STANDARD DEPARTURE CHART - INSTRUMENT

RJST / MATSUSHIMA

SID and TRANSITION

INSTRUMENT APPROACH CHART

MATSUSHIMA REVERSAL THREE DEPARTURE

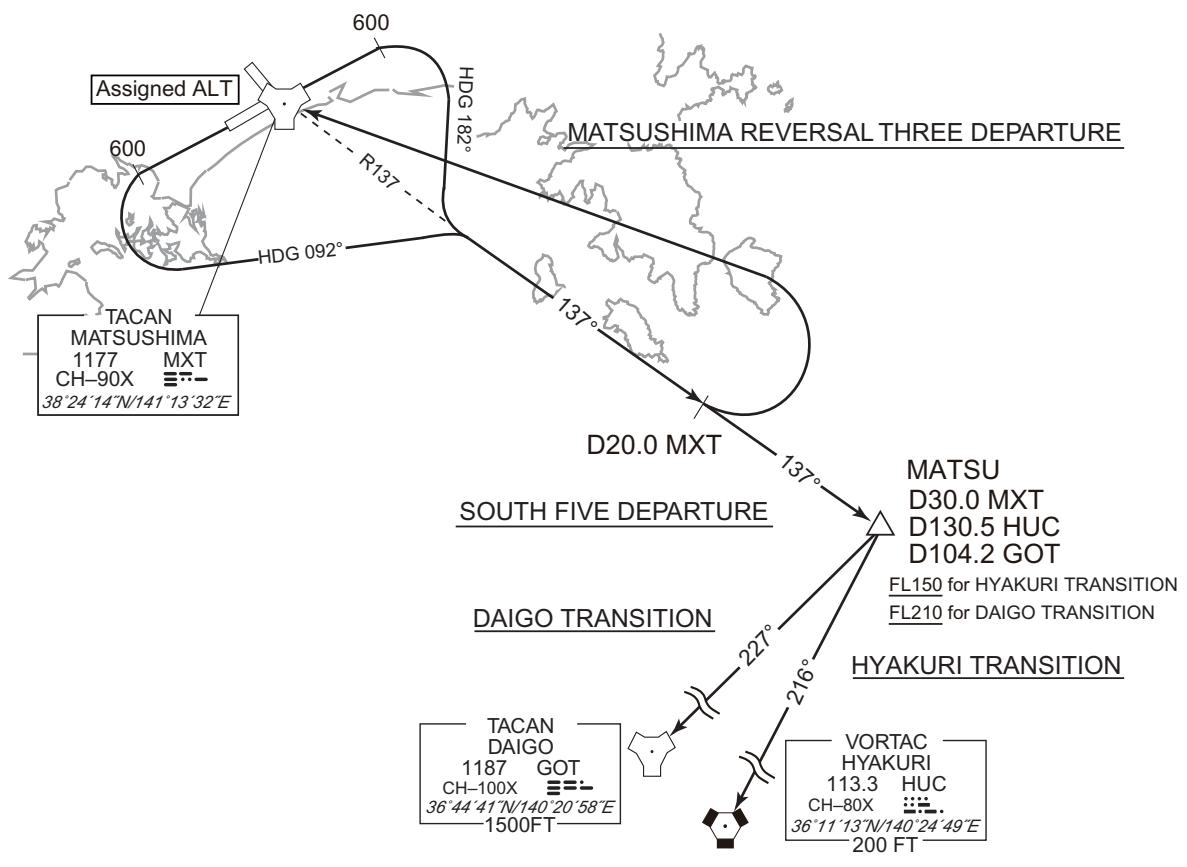
CHANGE : PROC renamed MATSUSHIMA REVERSAL THREE DEPARTURE, SOUTH FIVE DEPARTURE, Note(MATSUSHIMA REVERSAL THREE DEPARTURE, SOUTH FIVE DEPARTURE). ALT restriction for RWY07. Note added(HYAKURI TRANSITION).

NORTH FOUR DEPARTURE

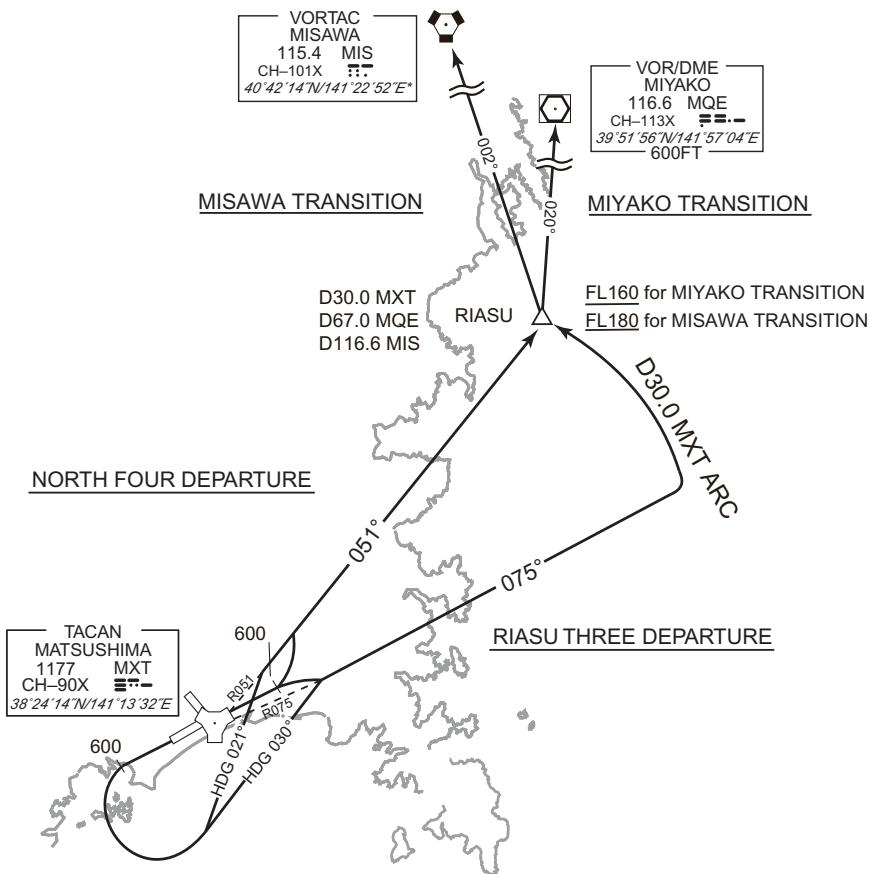
CHANGE : PROC renamed(NORTH FOUR DEPARTURE, RIASU THREE DEPARTURE). PROC course(NORTH FOUR DEPARTURE, RIASU THREE DEPARTURE), PROG course(NORTH FOUR DEPARTURE, RIASU THREE DEPARTURE). ALT restriction for RWY07. Note(NORTH FOUR DEPARTURE, RIASU THREE DEPARTURE).
 A note at the bottom left states: 'ALT restriction for RWY07. Note(NORTH FOUR DEPARTURE, RIASU THREE DEPARTURE).
 A note at the bottom right states: '30/11/23'

WEST FOUR DEPARTURE

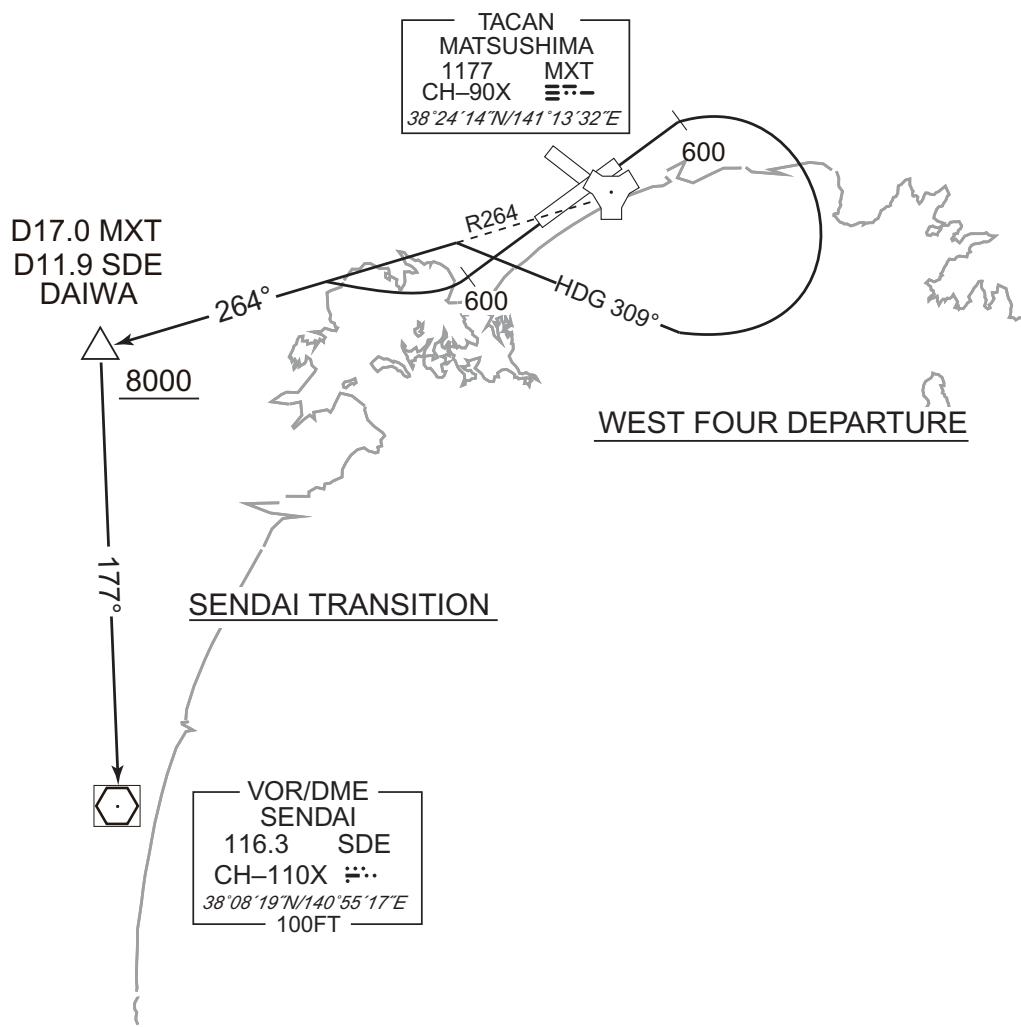
CHANGE : PROC renamed(WEST FOUR DEPARTURE), PPROC course(WEST FOUR DEPARTURE), NIIGATA TRANSITION abolished, ALT restriction for RWY07. Note(WEST FOUR DEPARTURE).

TACAN Y RWY25

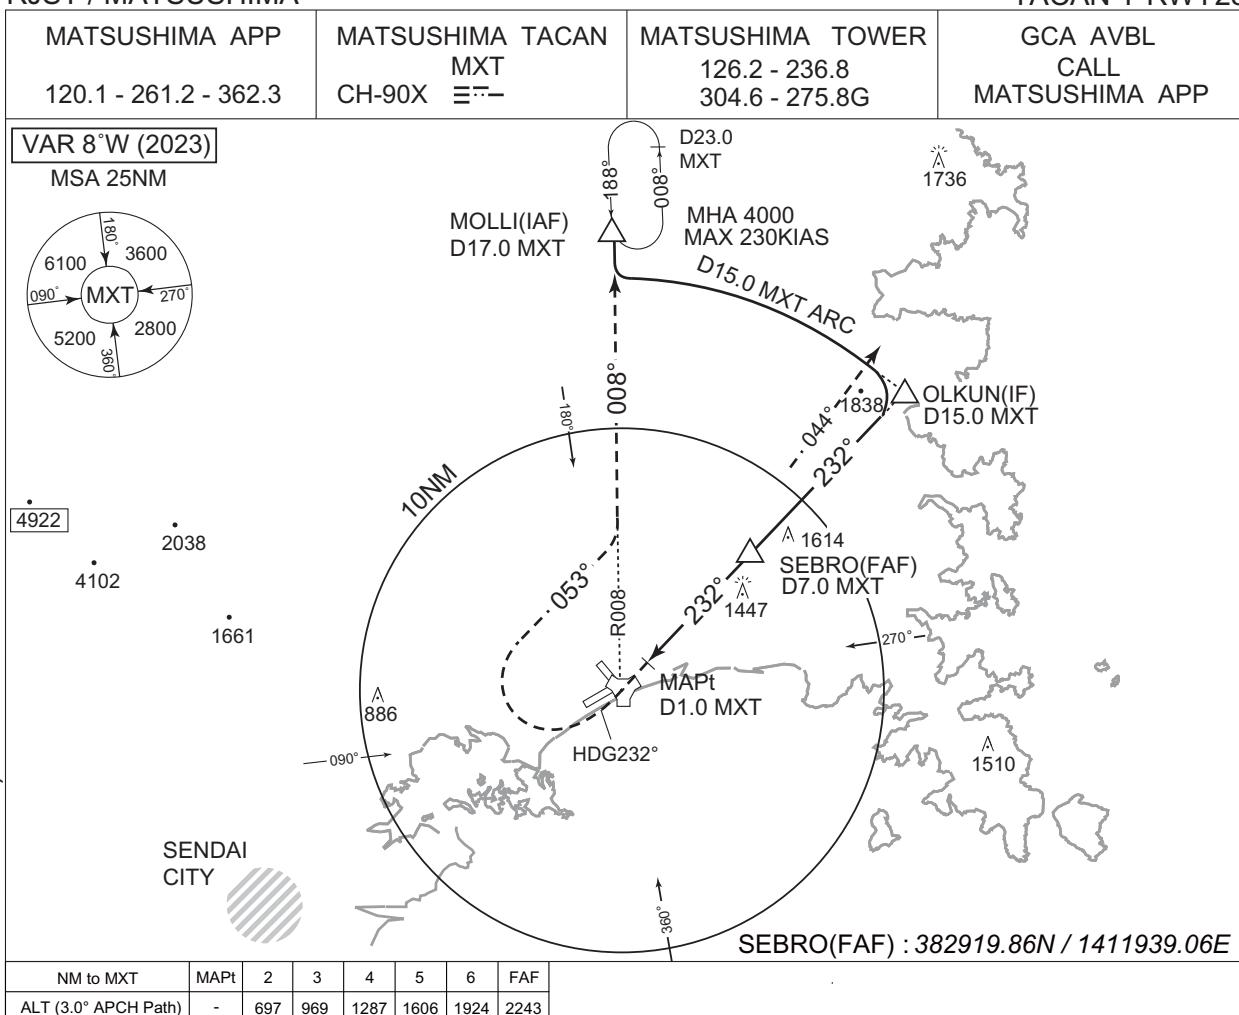
CHANGE : Correction of misdescription(Course FM MOLLI to OLKUN deleted).
